Errata OVI40 UI V1.8 Batch 1 Kit

Möglicher Kurzschluß (photo DF9EH)

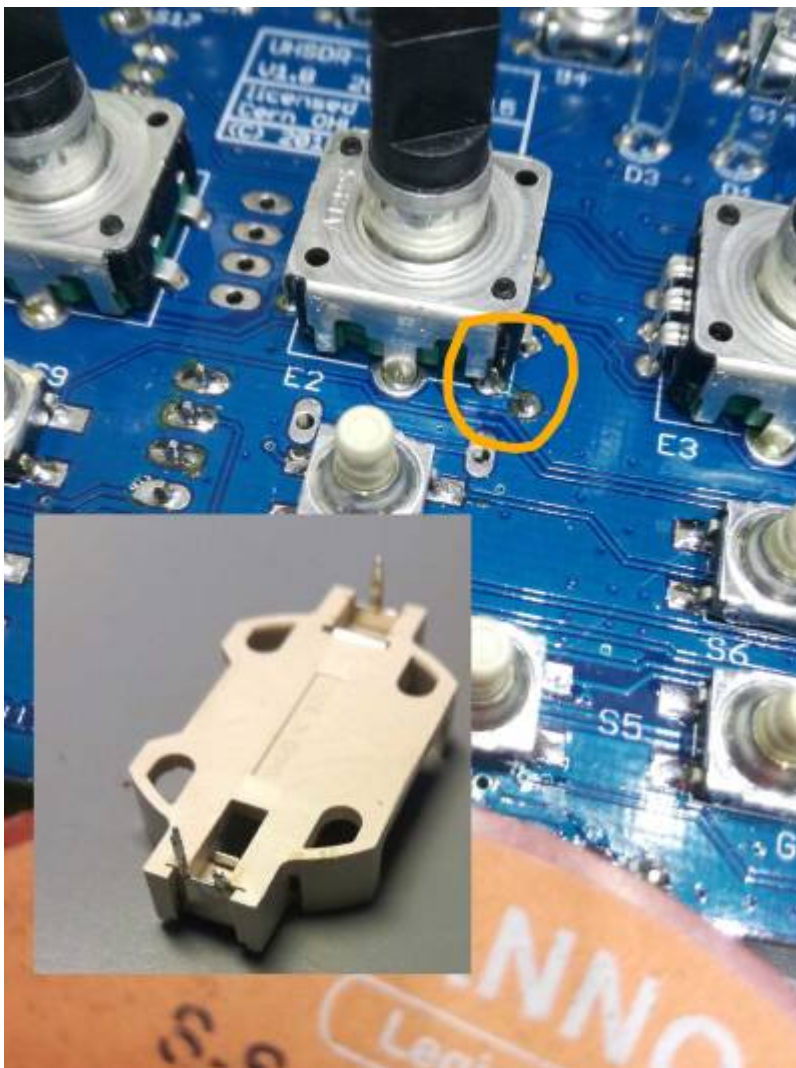
- Mini-USB socket J11 is "Type A" - this is wrong. "Type B" is mandatory to be used. Please get the correct part, e.g. Buerklin.de order number 72F2280
- The CR2032 back-up battery holder needs to be modified before soldering it in. On pin needs to be shortened so it is flush with the PCB surface TOP layer, see photo
